VALUE ENGINEERING PROPOSAL

PROPOSAL NO: S-11

DESCRIPTION Reduce Number of Control Houses

JUSTIFICATION:

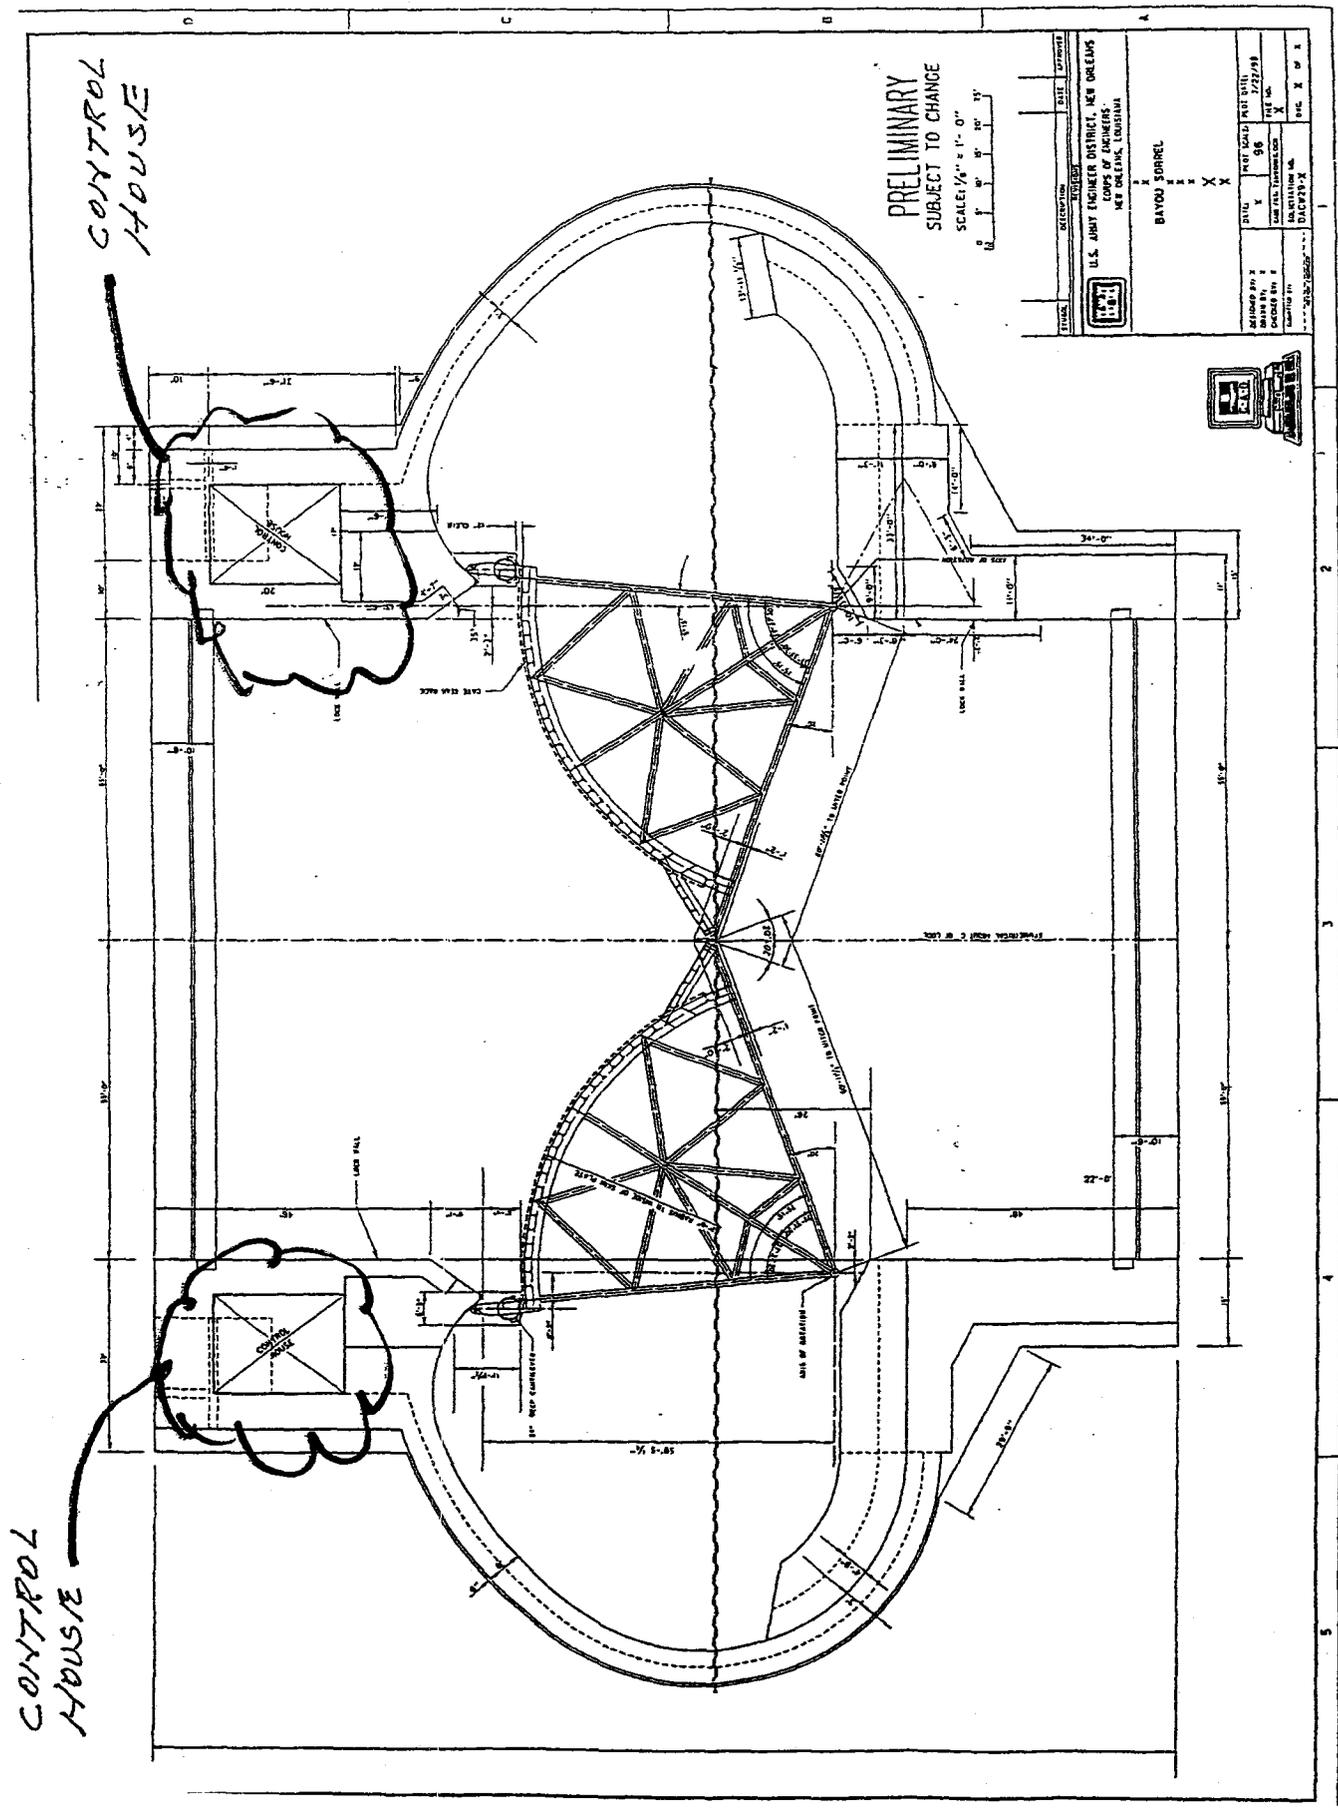
The new project will include a signal and communication system, which will incorporate a closed circuit television system. This will provide a view of significant lock locations on the facility from one control house. Plan drawings indicate that control houses are to be constructed on-site of masonry/metal and are not pre-engineered. The cost estimate, however, states pre-engineered building.
